# Service Bulletin

Starair Aircraft Co., Ltd.

Document No.: 2023-SA60L-28-03

Subject	<b>Operation training and optimization of fuel switching valve</b>
Category	Important
Applicability	This bulletin applies to the Aurora SA60L light sport aircraft listed in Attached Table 1.
Finish Time	Aircraft within the scope of application must be done the work required by this service bulletin completely before December 31, 2024.
Reason	<p>There are significant differences between the indications of the Aurora SA60L aircraft's fuel switching valve switching to the left, right, and close position. However, there have been recent incidents of pilots mistakenly switching the fuel switching valve to the close position, resulting in unsafe engine stoping in the air. In order to further improve flight safety and fault tolerance, aircraft operators are required to organize training on the operation of the fuel switching valve, At the same time, according to the required actions of this bulletin, replacement the fuel switching valve for aircraft within the scope of application (free).</p> <p>Issue Date: October 27, 2023      Effective Date: October 27, 2023</p>

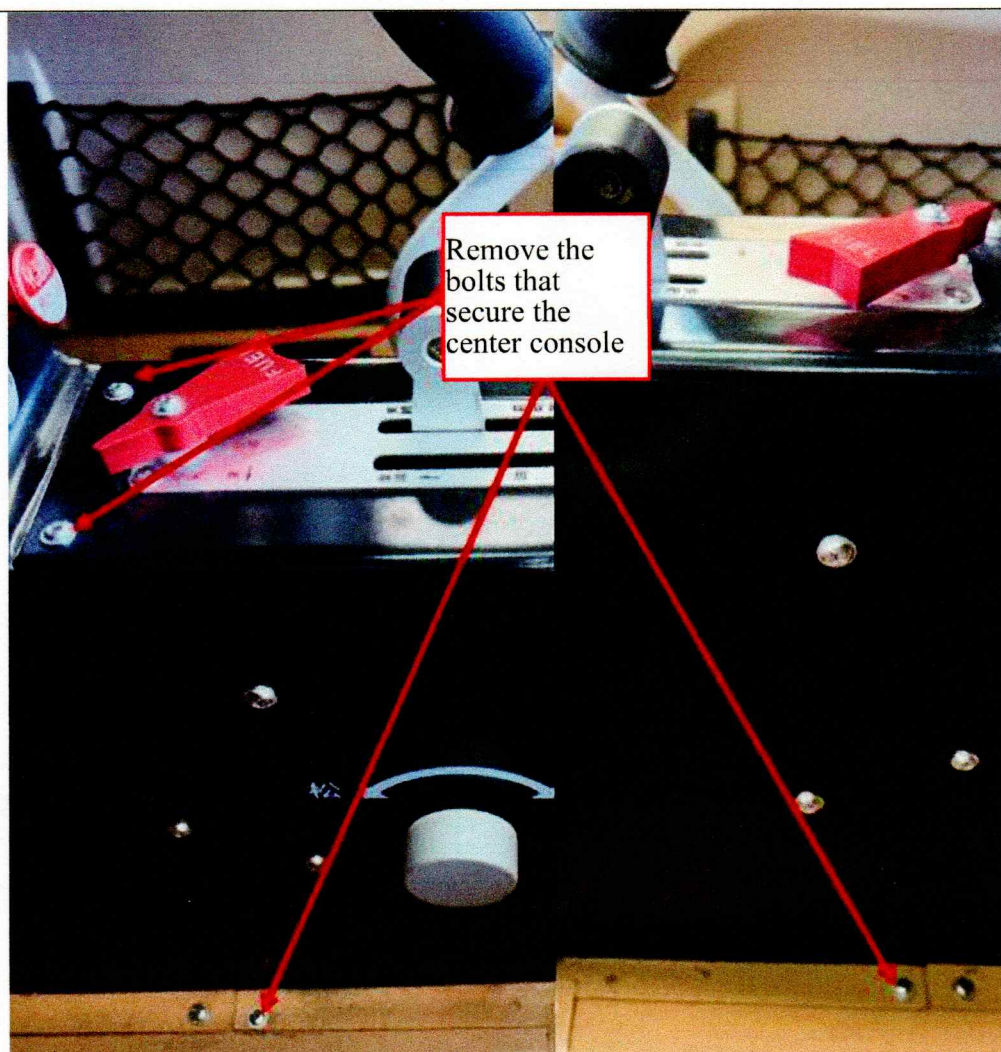
2. Remove the bolts between the valve stem and the connecting sleeve, then slowly rotate the fuel switching valve handle and simultaneously pull out the valve stem and handle upwards;

- 
- Remove the bolts from the throttle handle
- Remove the bolts that secure the throttle control mechanism assembly
- 松 ← 紧

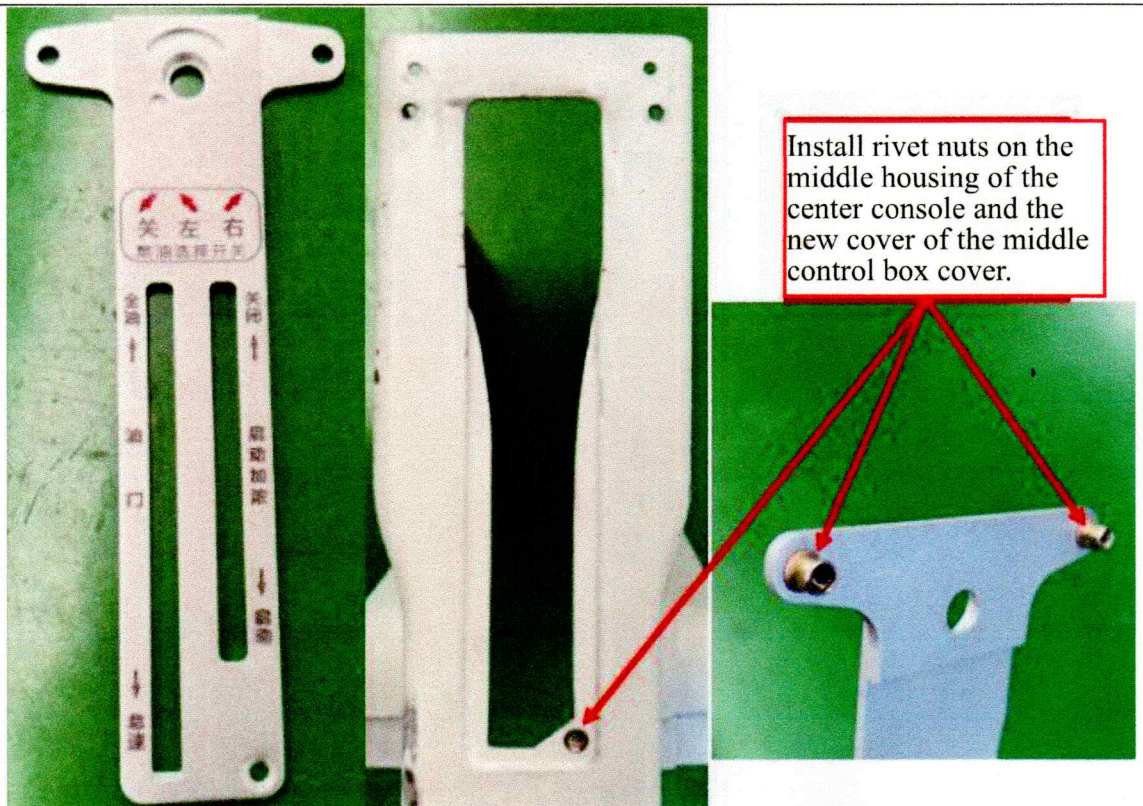
4. According to the size of the new cover of middle control box, repair the installation hole on the removed middle housing of the center console and install the rivet nuts.

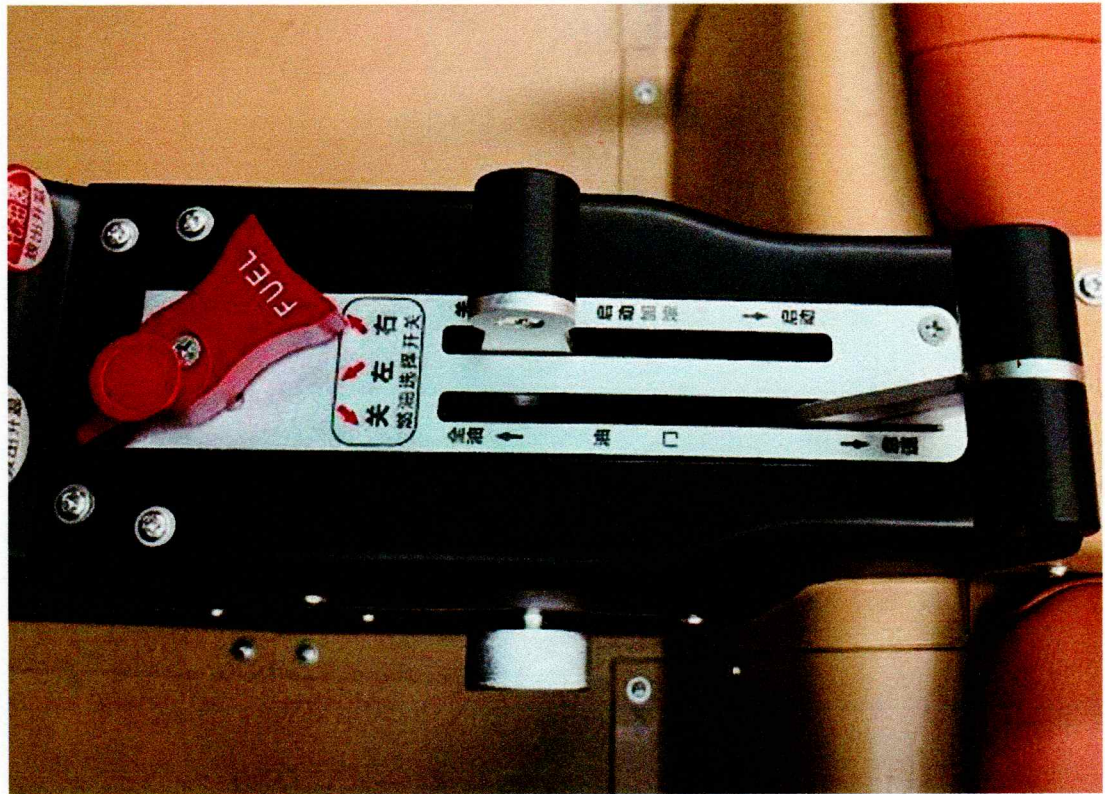
5. Assemble the optimized fuel switching valve handle and valve stem, as shown in the following figure.

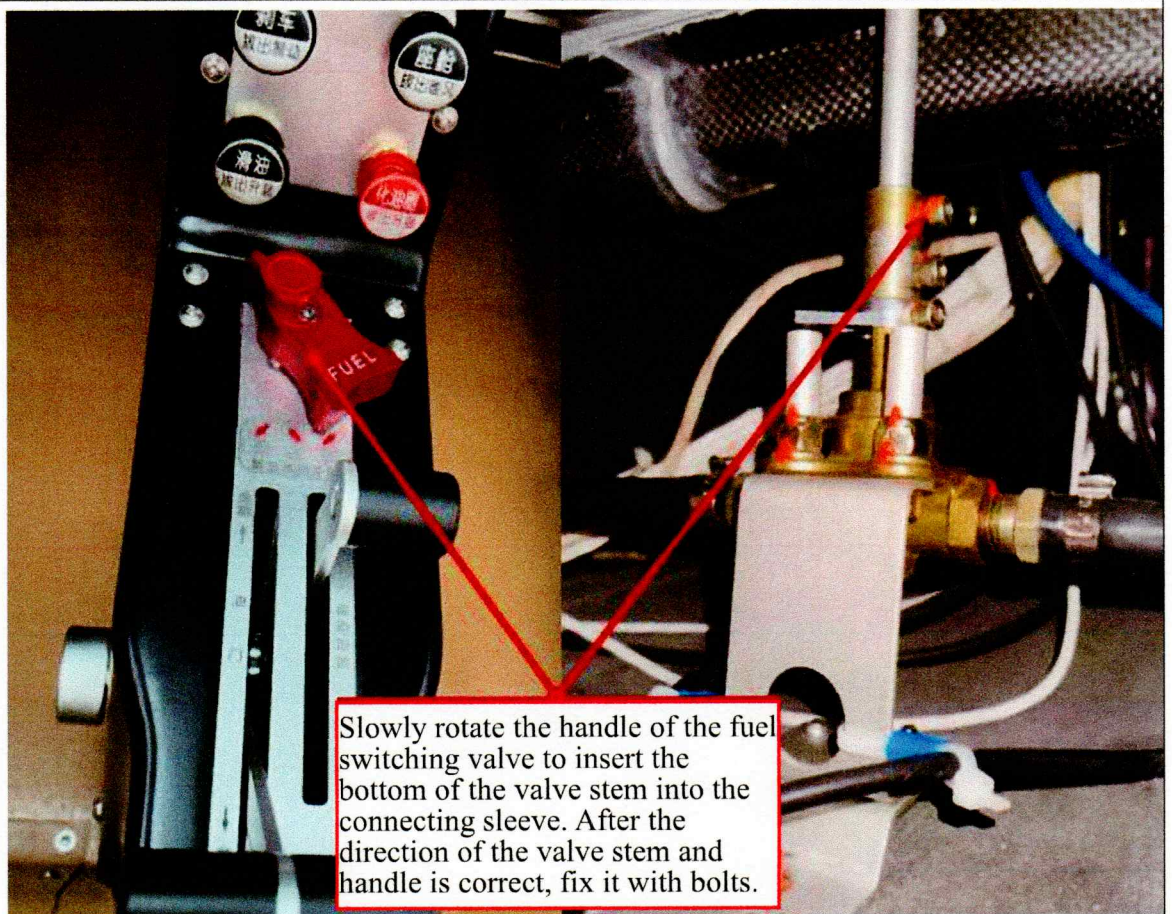
6. Assemble the optimized middle control box cover with the center console middle housing that has been repaired with the installation hole, then insert the handle and valve stem assembled in step 5 into the installation hole of middle control box cover and install them together on the aircraft. Finally install the throttle assembly and other fasteners, as shown in the following figure.

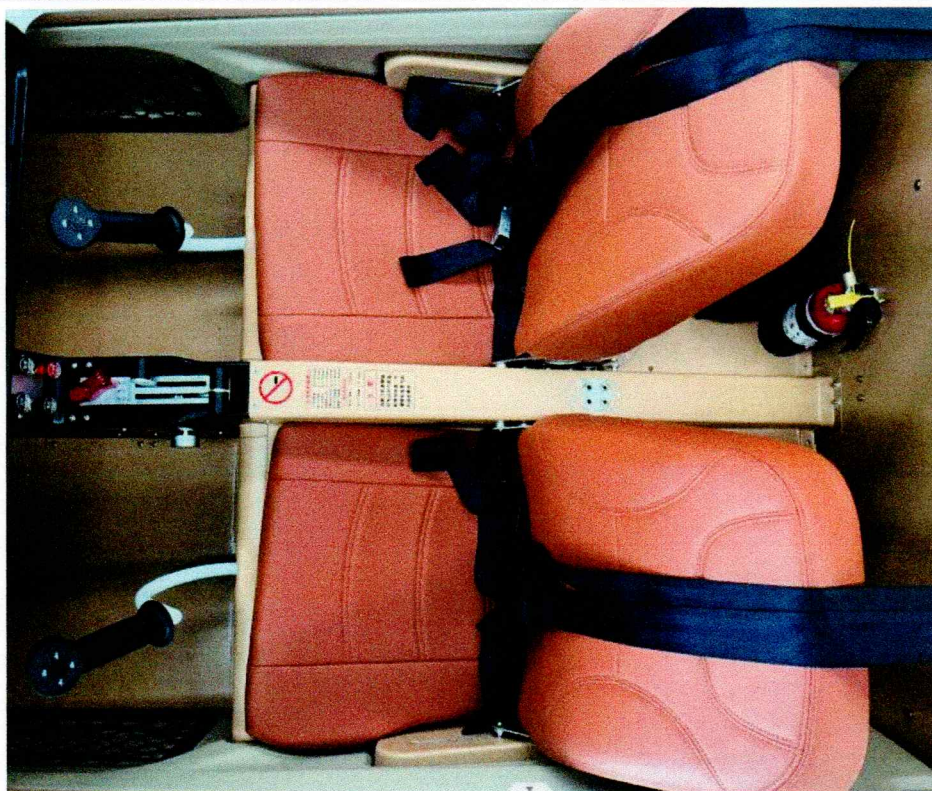
7. After adjusting the length and rotation direction of the valve stem, use screws to install and fix the bottom of the valve stem with the connecting sleeve, as shown in the following figure.
